PLANT NAME: NINE MILE POINT UNIT #1

Info re postulated pipe failure outside containment structure for Nine Mile Point Unit #1

Mr. D. L. Ziemann, Chief
Operating Reactors Branch #2
Directorate of Licensing
United States Atomic Energy Commission
Washington, D. C. 20545

Re: Nine Mile Point Unit 1
Docket No. 50-220

FIGURE 2-1

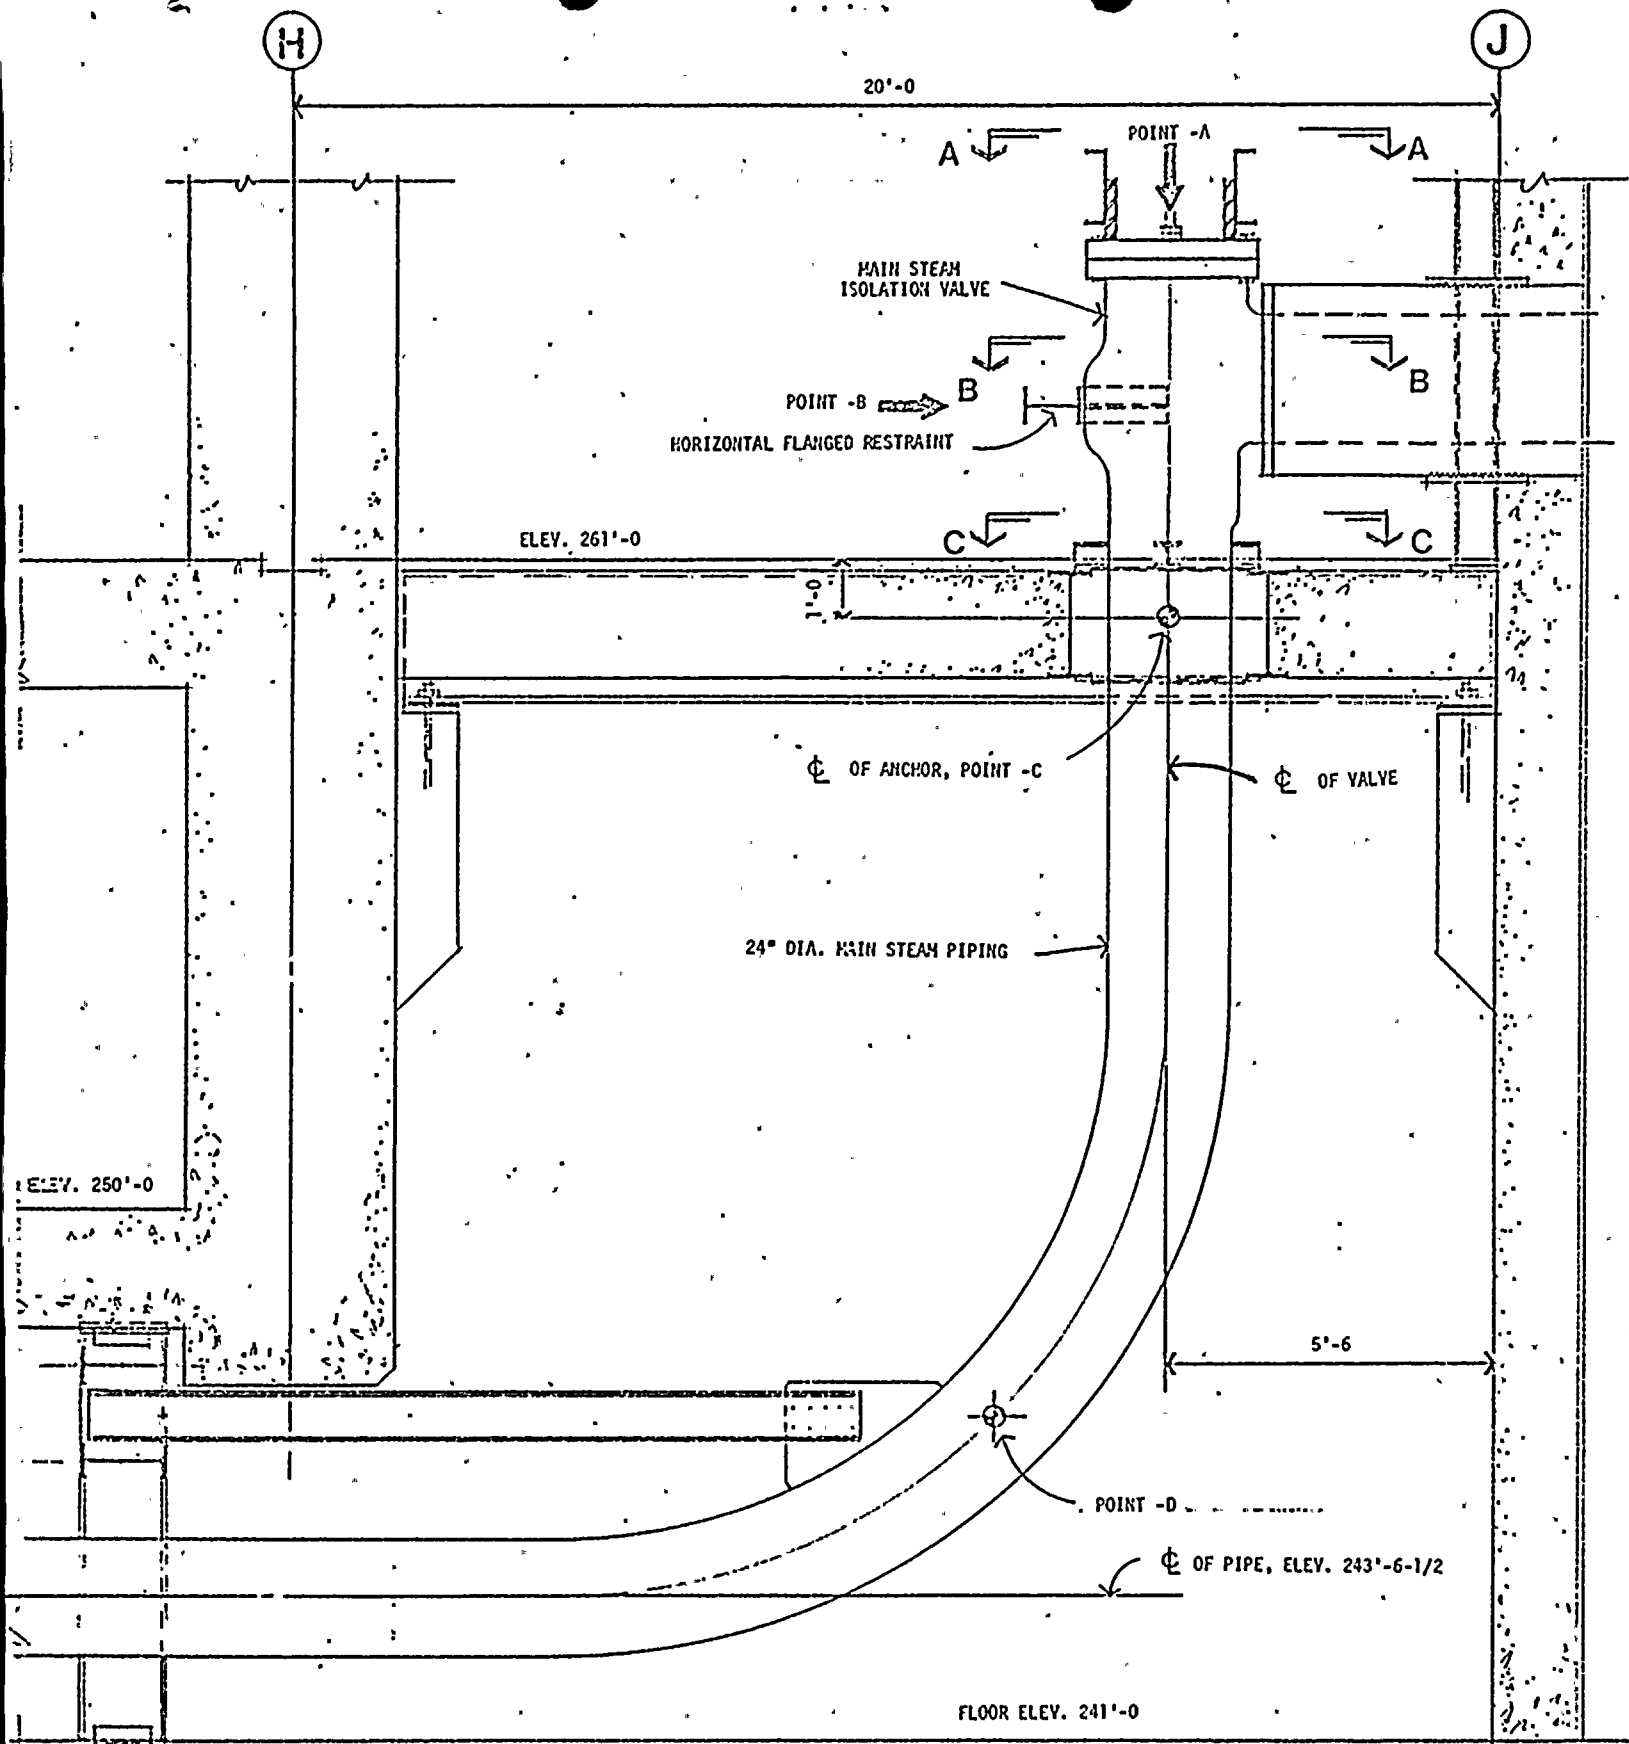
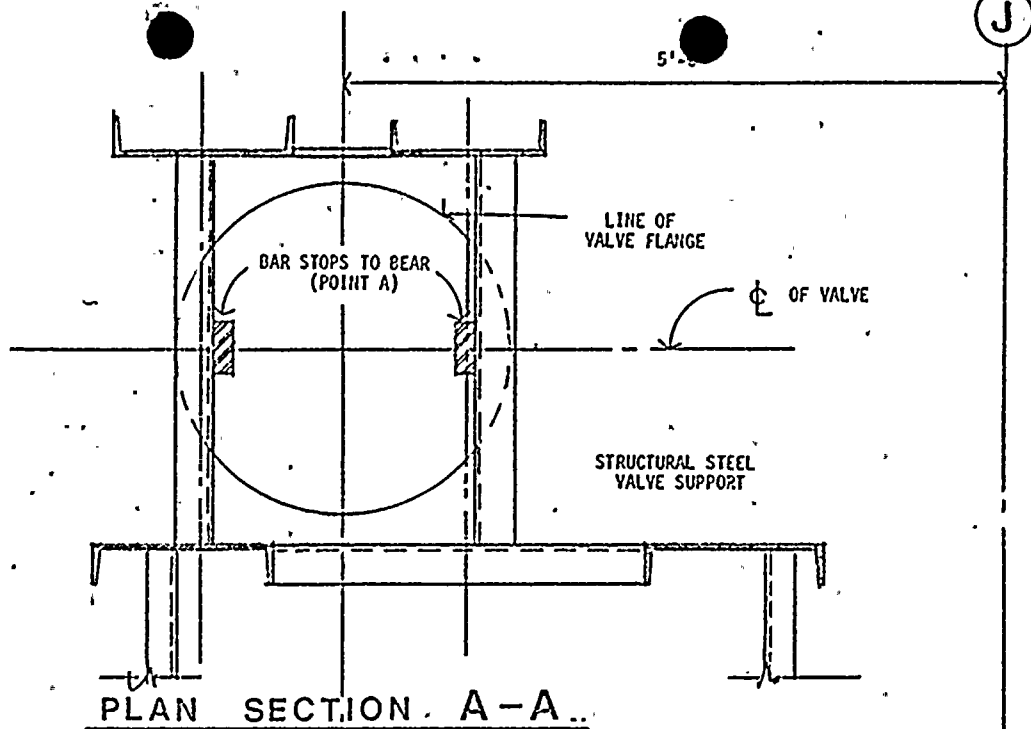
Describe the anchors at the main steam line isolation valves and/or the seismic restraints designed as pipe whipping restraints.

The main steam isolation valves are supported as shown in Figures 2-1 and 2-2. Points A, B and D are designed to resist a guillotine break in the main steam line on either side of the valve. The design force for this pipe break is 240 kips. Point C is an anchor point for thermal and seismic forces.
